# UNITED STATES PATENT AND TRADEMARK OFFICE

APPLICATION NO.	FILING DATE	FIRST NAMED INVENTOR	ATTORNEY DOCKET NO.	CONFIRMATION NO.
09/973,560	10/09/2001	Mark A. Johnson	RD-28,600	7497

# Office Action Summary

Figure 1 - U.S. Patent 5,440,606 to Faul et al.

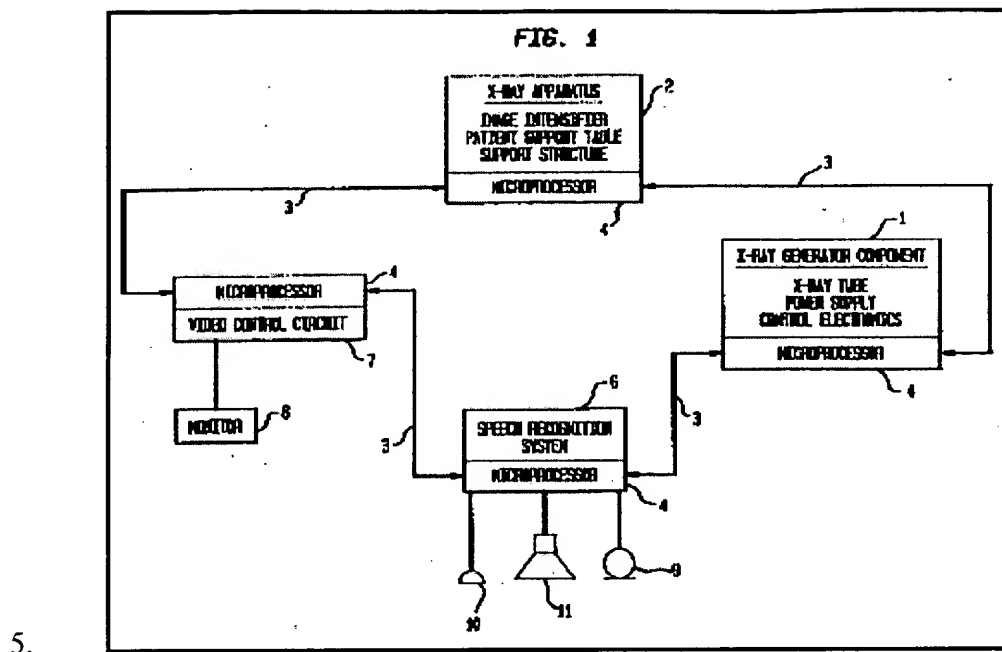
6. As per claim 13, Faul et al. disclose an apparatus comprising an x-ray source (1) a detector (2) a patient table (2 - column 2, lines 25-31) a video monitor (8) and a voice activated control system (6) comprising a microphone (9) and micro-processor (column 3, lines 21-25); the processing comprising at least one word and phrase recognition (column 2, lines 64-68, column 3, lines 1-31); the control system (6) coupled to controls for at least one of the x-ray source (1), detector (2) and monitor (8) for executing commands received by the control system (Fig. 1, above; abstract). Examiner treats the presence of an audio amplifier as an inherent device within a microphone; the device functioning to receive and amplify acoustical signals.

7. As per claim 16, Faul et al. disclose an apparatus further comprising a speaker (11).
8. As per claim 18, Faul et al. disclose an apparatus wherein controls comprise x-ray generator controls (4) and image review controls (4).

11. As per claims 14 and 15, Faul et al. do not explicitly disclose an apparatus comprising an audio amplifier or a highly directional microphone.

12. It would have been obvious to modify the apparatus of Faul et al. such that it incorporated an audio amplifier and a highly directional microphone. One would have been motivated to make such a modification so that low or soft voice commands are sensed from any position relative to the microphone and amplified so that system components can correctly interpret the received commands, resulting in efficient device operation.

13. As per claim 17, Faul et al. do not explicitly disclose an apparatus wherein the x-ray source, detector, monitor and microphone are located in an exam room with a microphone sensitivity zone located therein.

14. It would have been obvious to modify the apparatus of Faul et al. such that it was located in an exam room with a microphone sensitivity zone located therein. One would have been motivated to make such a modification so that operator voice commands could be easily received by the control system while the examination of a patient is simultaneously being carried out.
